SAN ONOFRE NUCLEAR GENERATING STATION, UNIT 2

AMENDMENT TO FACILITY OPERATING LICENSE

Amendment No. 30
License No. NPF-10

ATTACHMENT TO LICENSE AMENDMENT NO. 30

FIGURE 3.1 - 1A

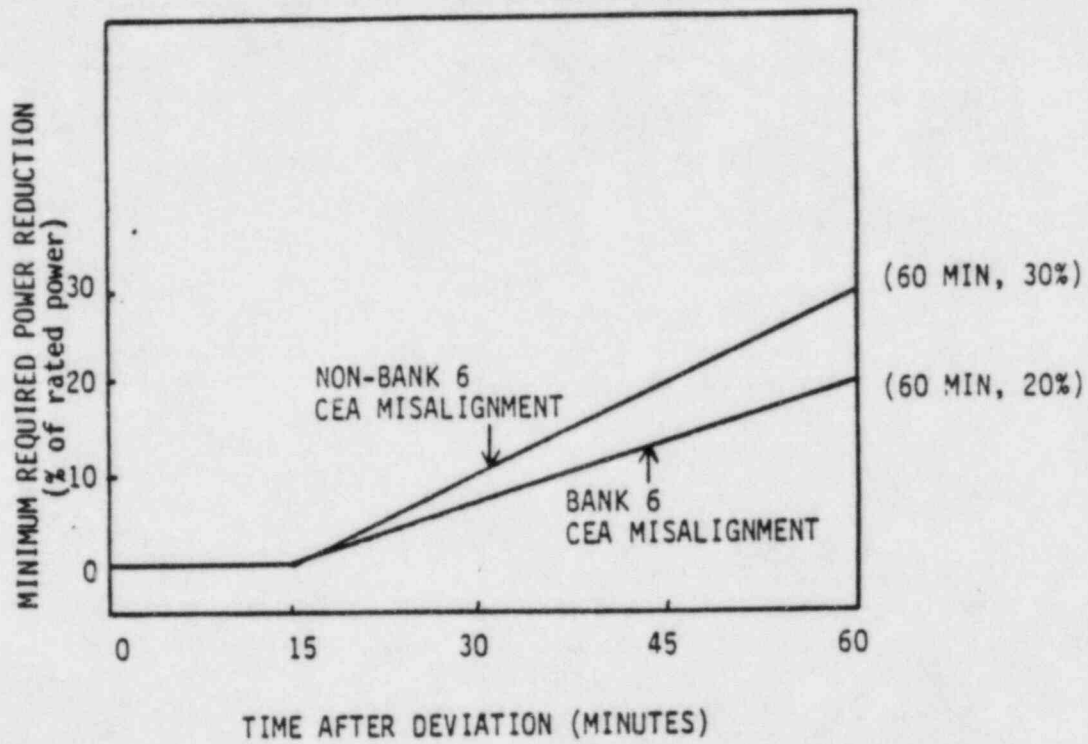
- c. With one full length or part length CEA misaligned from any other CEA in its group by more than 19 inches, operation in MODES 1 and 2 may continue, provided that core power is reduced in accordance with Figure 3.1-1A and that within one hour the misaligned CEA is either:

- d. With one or more full length or part length CEAs misaligned from any other CEAs in its group by more than 7 inches but less than or equal to 19 inches, operation in MODES 1 and 2 may continue, provided that core power is reduced in accordance with Figure 3.1-1A and that within one hour the misaligned CEA(s) is either:

* When core power is reduced to 60% of rated power per this limit curve, further reduction is not required by this specification.

Figure 3.1-2

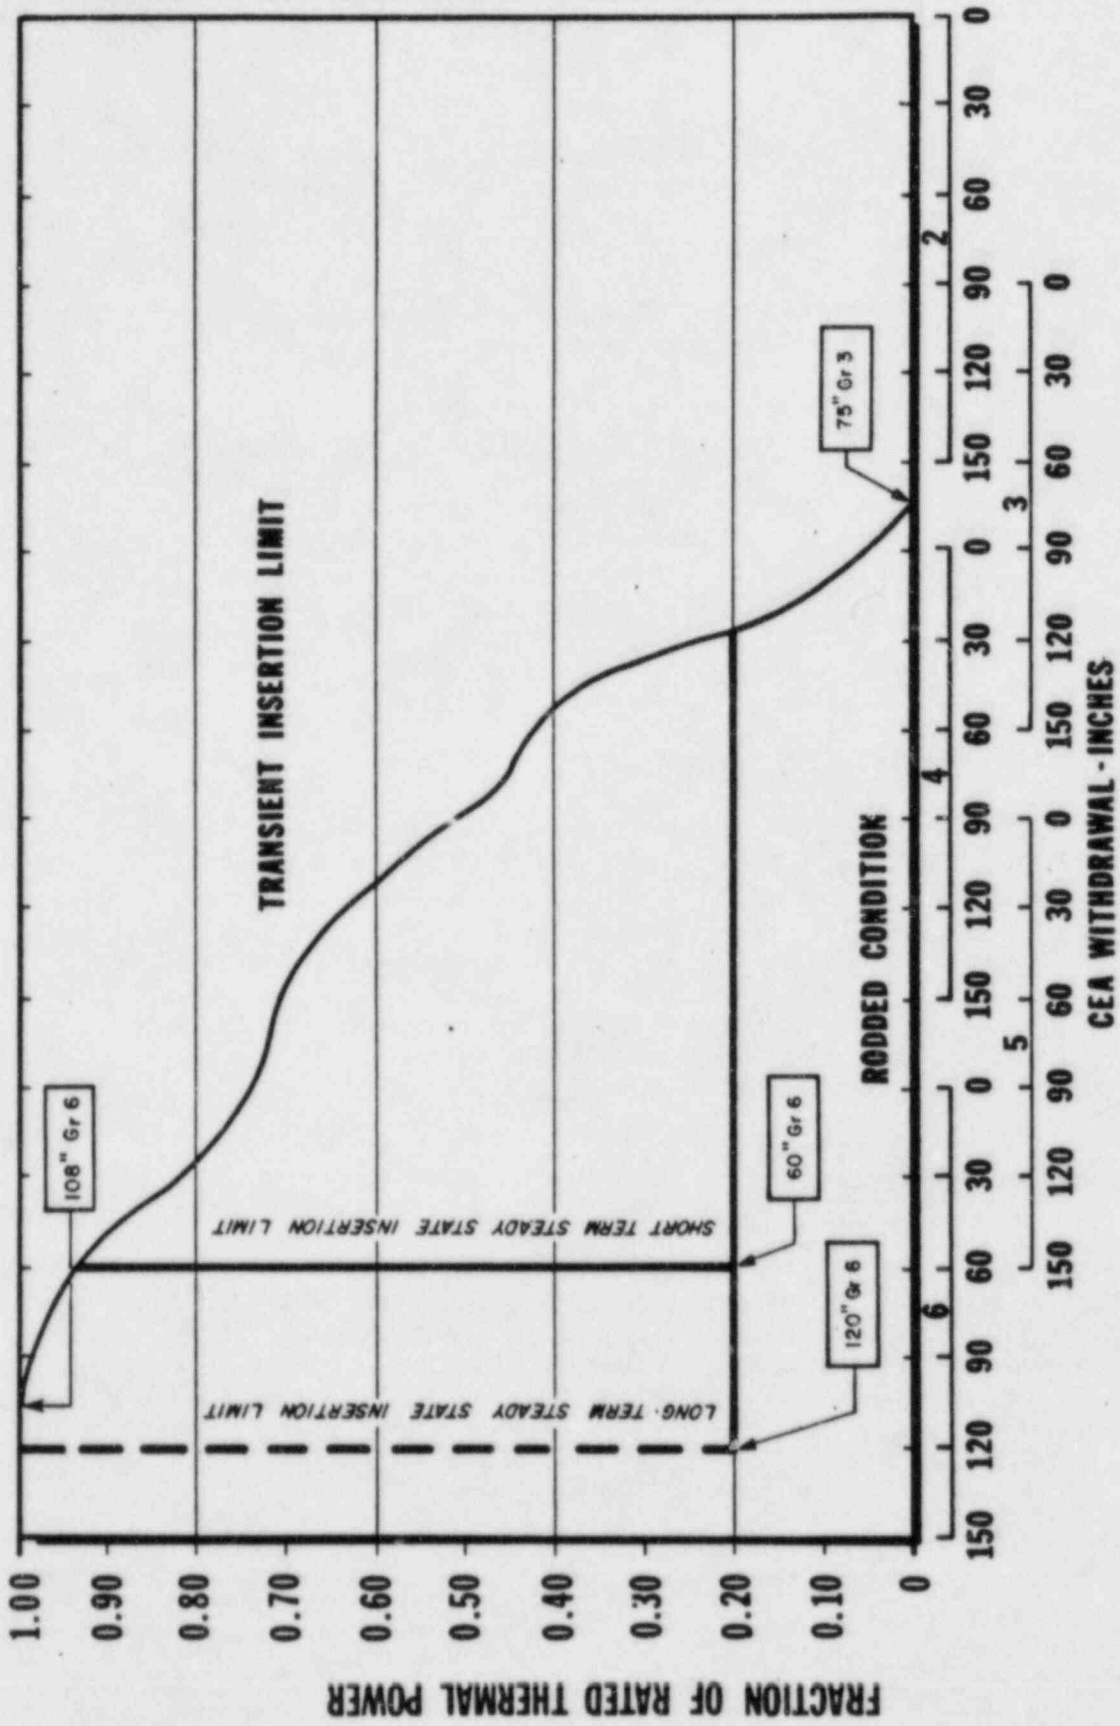
- a. When COLSS is in-service, the regulating CEA groups shall be limited to the withdrawal sequence and to the insertion limits shown on Figure 3.1-2. The CEA insertion between the Long Term Steady State Insertion Limits and the Transient Insertion Limits is restricted to:
 1. Less than or equal to 4 hours per 24 hour interval,
 2. Less than or equal to 5 Effective Full Power Days per 30 Effective Full Power Day Interval, and
 3. Less than or equal to 14 Effective Full Power Days per calendar year.

- b. When COLSS is out-of-service, the regulating CEA groups shall be limited to the Short Term Steady State Insertion Limit shown on Figure 3.1-2. The CEA insertion between the Long Term Steady State Insertion Limits and the Short Term Steady State Insertion Limits is restricted to:
 1. Less than or equal to 4 hours per 24 hour interval,
 2. Less than or equal to 5 Effective Full Power Days per 30 Effective Full Power Day Interval, and
 3. Less than or equal to 14 Effective Full Power Days per calendar year.

- b. With the regulating CEA groups inserted between the Long Term Steady State Insertion Limits and the Transient Insertion Limits for intervals greater than 4 hours per 24 hour interval, operation may proceed provided either:
 - 1. The Short Term Steady State Insertion Limits of Figure 3.1-2 are not exceeded, or
 - 2. Any subsequent increase in THERMAL POWER is restricted to less than or equal to 5% of RATED THERMAL POWER per hour.
- c. With the regulating CEA groups inserted between the Long Term Steady State Insertion Limits and the Transient Insertion Limits for intervals greater than 5 EFPD per 30 EFPD interval or greater than 14 EFPD per calendar year, either:
 - 1. Restore the regulating groups to within the Long Term Steady State Insertion Limits within two hours, or
 - 2. Be in at least HOT STANDBY within 6 hours.

Figure 3.1-3 PART I CEA INSERTION LIMIT vs. THERMAL POWER

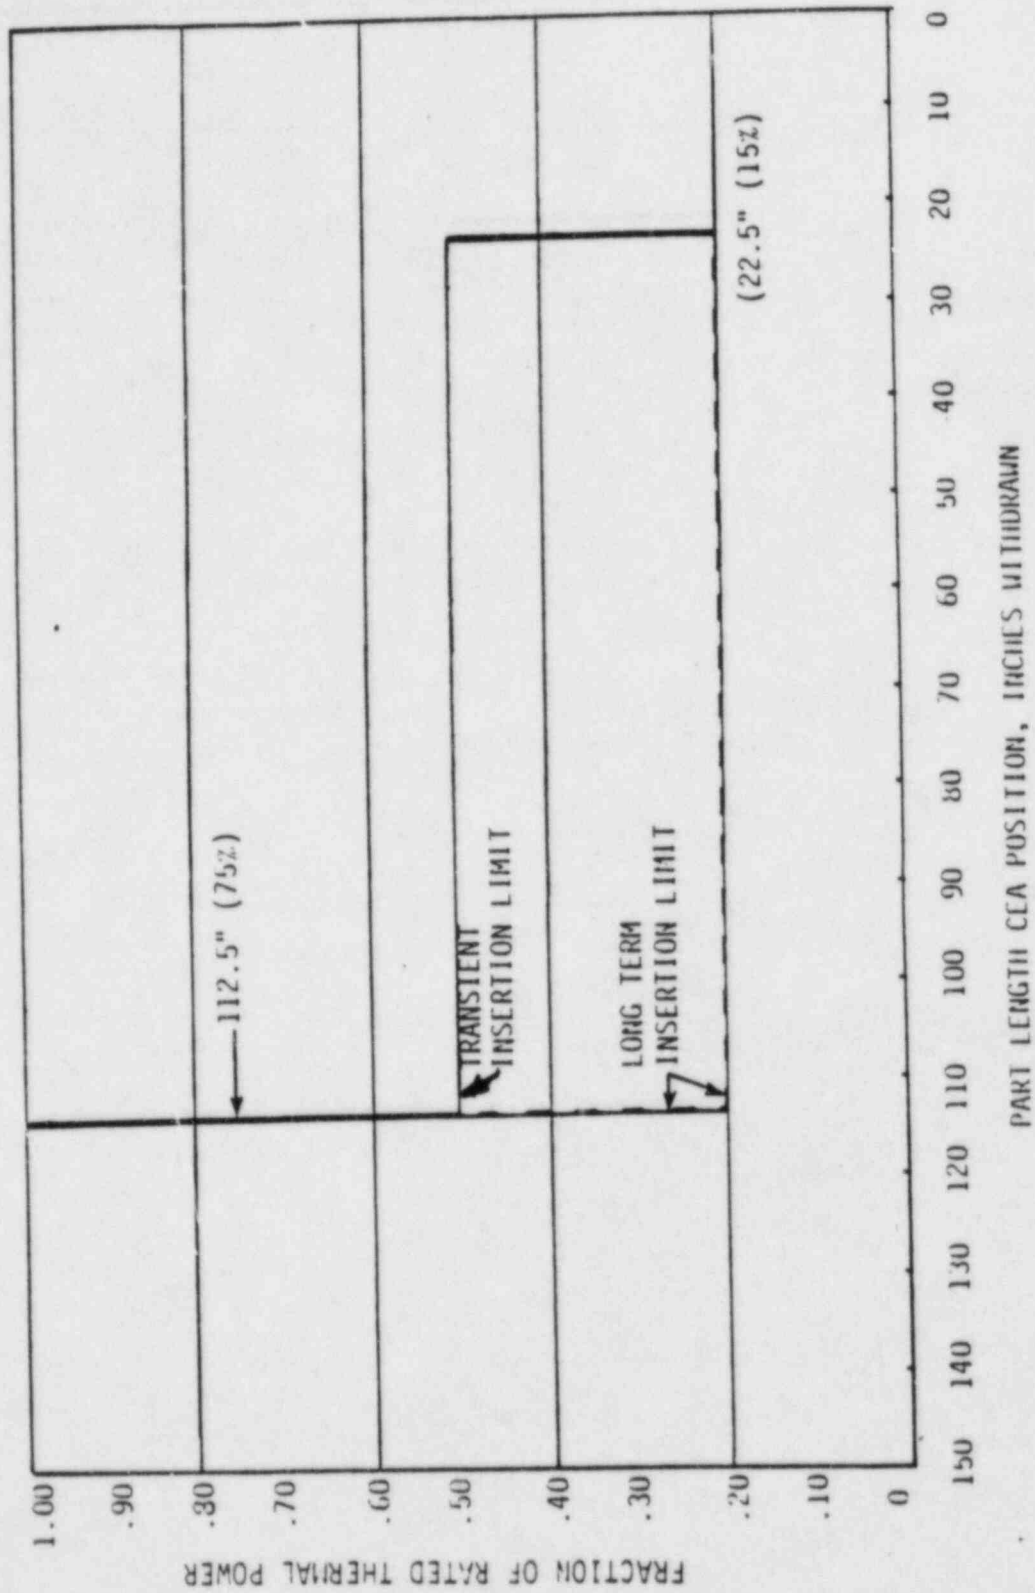
3.1.3.7 The position of the part length CEA group shall be restricted to prevent the neutron absorber section of the part length CEA group from covering the same axial segment of the fuel assemblies for a period in excess of 7 EFPD out of any 30 EFPD period. The position of the part length CEA group shall also be limited to the insertion limits shown on Figure 3.1-3.

FIGURE 3.1-1A

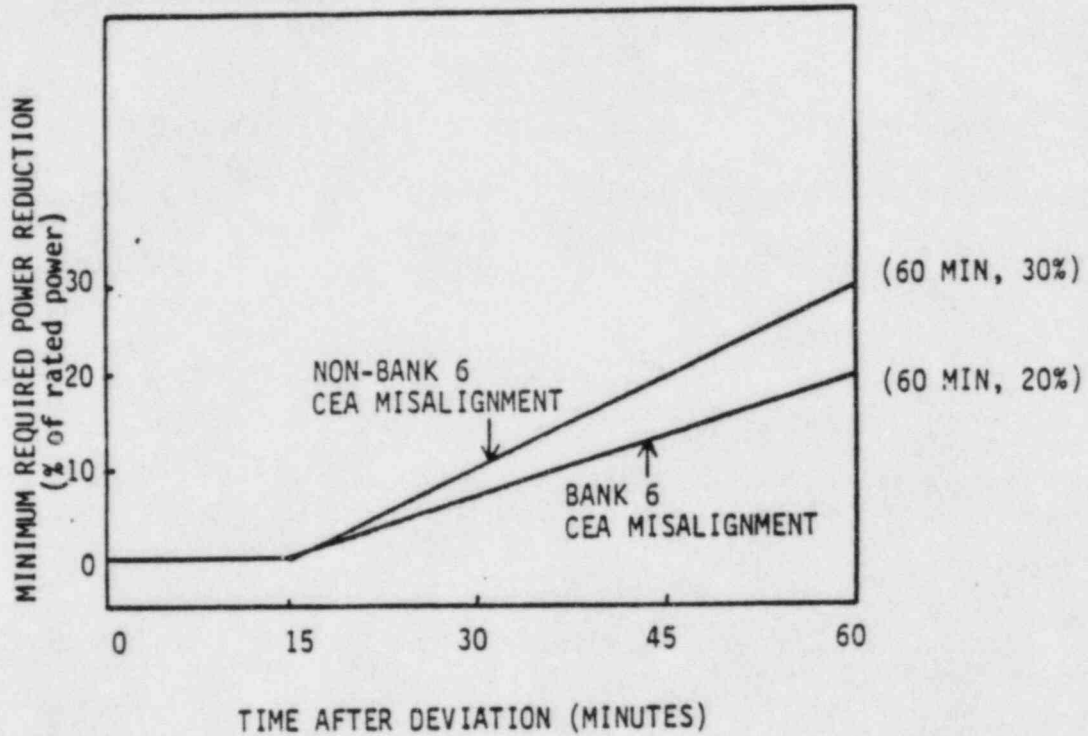
- c. With one full length or part length CEA misaligned from any other CEA in its group by more than 19 inches, operation in MODES 1 and 2 may continue, provided that core power is reduced in accordance with Figure 3.1-1A and that within one hour the misaligned CEA is either:

- d. With one or more full length or part length CEAs misaligned from any other CEAs in its group by more than 7 inches but less than or equal to 19 inches, operation in MODES 1 and 2 may continue, provided that core power is reduced in accordance with Figure 3.1-1A and that within one hour the misaligned CEA(s) is either:

* When core power is reduced to 60% of rated power per this limit curve, further reduction is not required by this specification.

Figure 3.1-2
 CEA insertion limits vs fraction
 of allowable thermal power

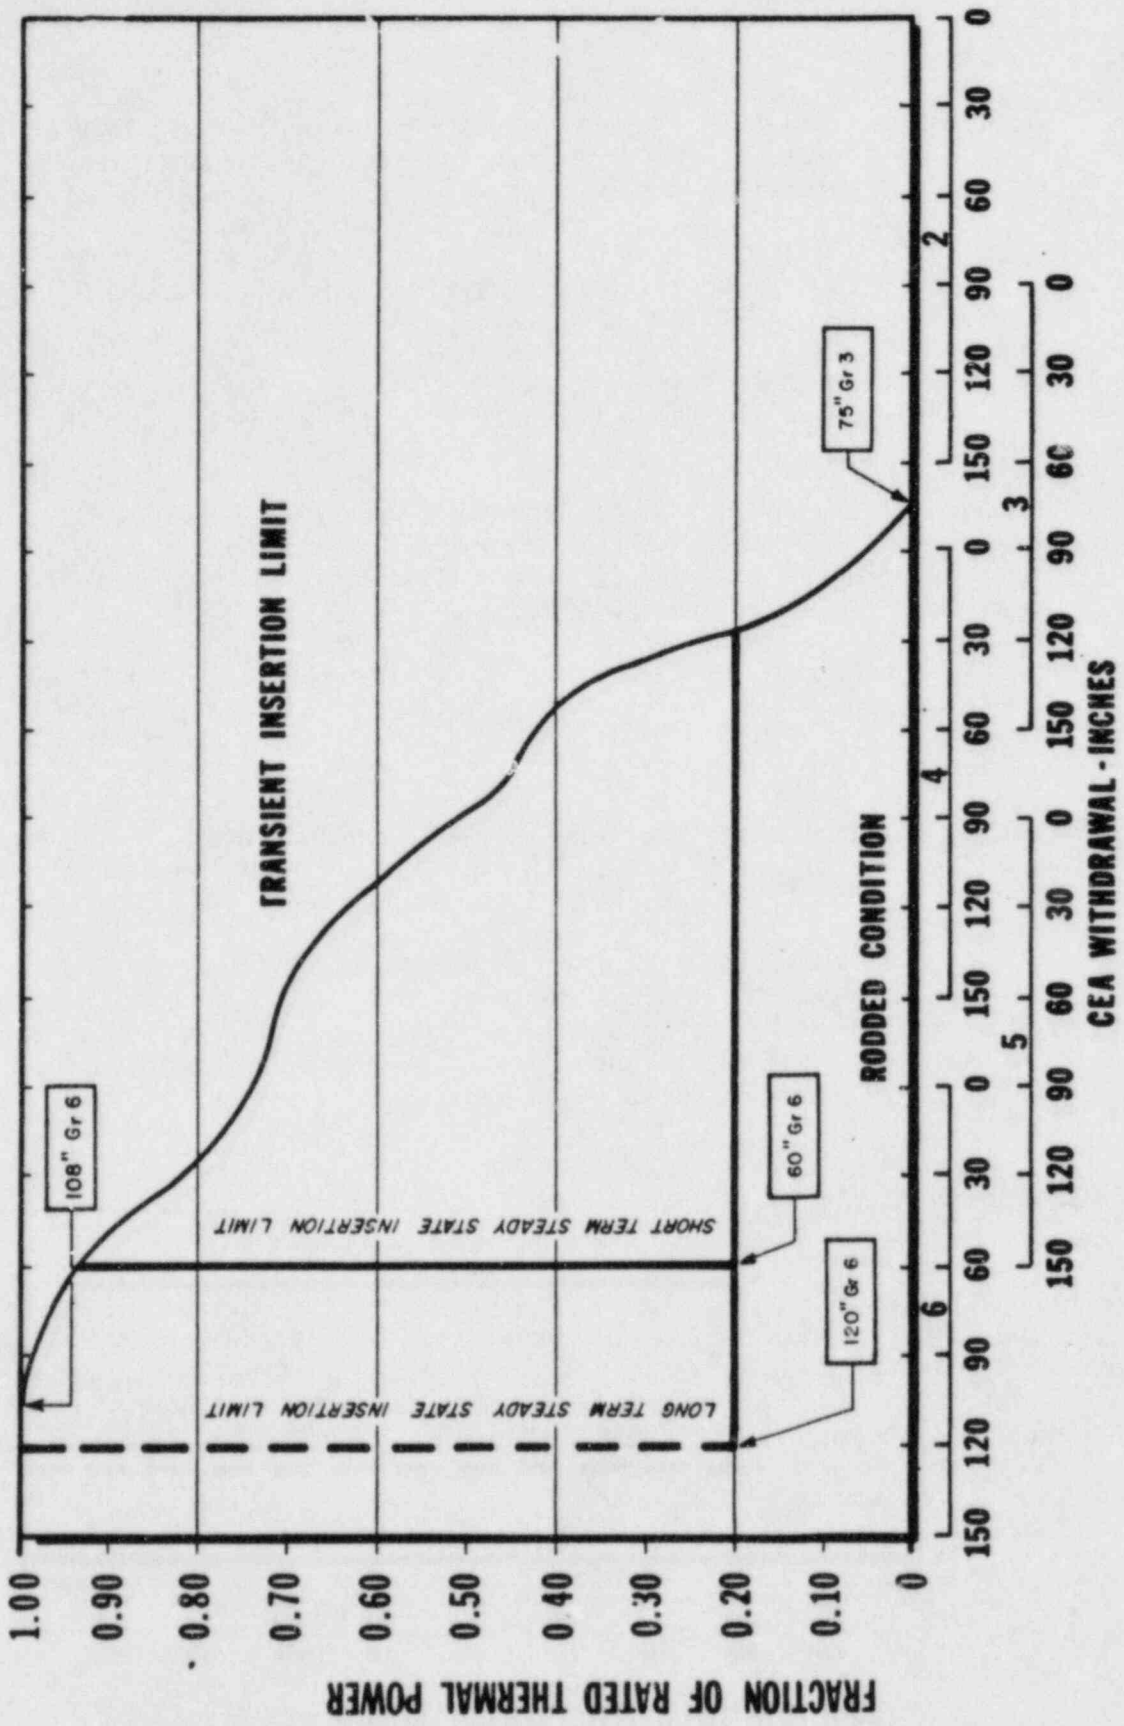
- a. When COLSS is in-service, the regulating CEA groups shall be limited to the withdrawal sequence and to the insertion limits shown on Figure 3.1-2. The CEA insertion between the Long Term Steady State Insertion Limits and the Transient Insertion Limits is restricted to:

3. Less than or equal to 14 Effective Full Power Days per calendar year.
- a. When COLSS is out-of-service, the regulating CEA groups shall be limited to the Short Term Steady State Insertion Limit shown on Figure 3.1-2. The CEA insertion between the Long Term Steady State Insertion Limits and the Short Term Steady State Insertion Limits is restricted to:

- b. With the regulating CEA groups inserted between the Long Term Steady State Insertion Limits and the Transient Insertion Limits for intervals greater than 4 hours per 24 hour interval, operation may proceed provided either:
 1. The Short Term Steady State Insertion Limits of Figure 3.1-2 are not exceeded, or
 2. Any subsequent increase in THERMAL POWER is restricted to less than or equal to 5% of RATED THERMAL POWER per hour.
